Access Compliance Report

Public Rights-of-Way

(Curb Ramps)

Intersection ID: 14378	Main Street: WORTHINGTON_AV	Cross Street: EUCLID_AV	Location:	E
ADA ID: A787959D2F05	Ramp Type: Perp	Initial Pass/Fail: Fail	Overall Compliance: No	Severity Score: 10
Codes/Mitigation Info/Possible Solution		Field Measurements/Component Compliance

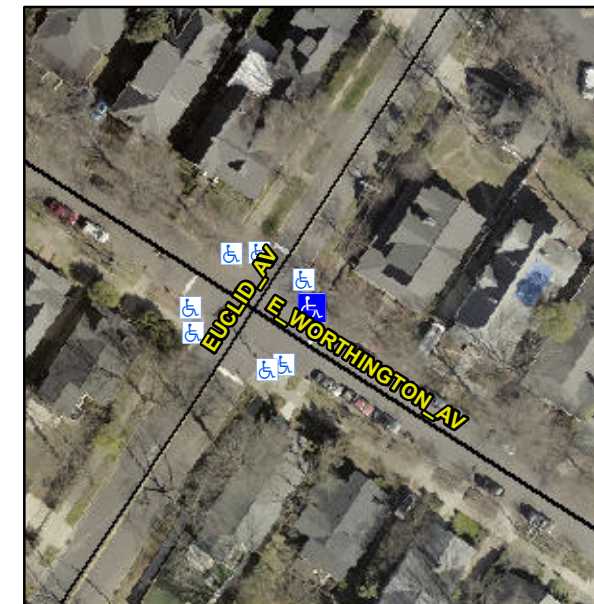
Not Found, R304.5.1, R304.5.3

Compliance	Description	Data	Compliance	Description	Data
N/A	Ramp Length (in)	109.0	Yes	Ramp Slope (%)	5.1
No	Ramp Width (in)	47.0	No	Ramp XSlope (%)	2.4
N/A	Flare Type LT	N/A	N/A	Flare Type RT	N/A
N/A	Flare Slope LT (%)	N/A	N/A	Flare Slope RT (%)	N/A
N/A	Flare Traversable LT?	N/A	N/A	Flare Traversable RT?	N/A
N/A	Landing Length (in)	N/A	N/A	DWS Provided?	N/A
N/A	Landing Width (in)	N/A	N/A	DWS Contrast?	N/A
N/A	Landing Slope (%)	N/A	N/A	DWS Length (in)	N/A
N/A	Landing X Slope (%)	N/A	N/A	DWS Full Width?	N/A
N/A	Landing Curb? (Y/N)	N/A	N/A	DWS Offset (in)	N/A
N/A	Shared Landing?	N/A			
N/A	Gutter Ponding?	N/A	N/A	Gutter Slope (%)	N/A
N/A	Gutter Lip Ht (in)	N/A	N/A	Gutter X Slope (%)	N/A
N/A	Painted X Walk1?	No	N/A	Painted X Walk2?	N/A
	X Walk 1 Direction	To SW		X Walk 2 Direction	N/A
N/A	X Walk 1 Width (in)	N/A	N/A	X Walk 2 Width (in)	N/A
	X Walk 1 Slope (%)	3.7		X Walk 2 Slope (%)	N/A
	X Walk 1 X Slope (%)	1.2		X Walk 2 X Slope (%)	N/A

Remove & Replace Entire Ramp.
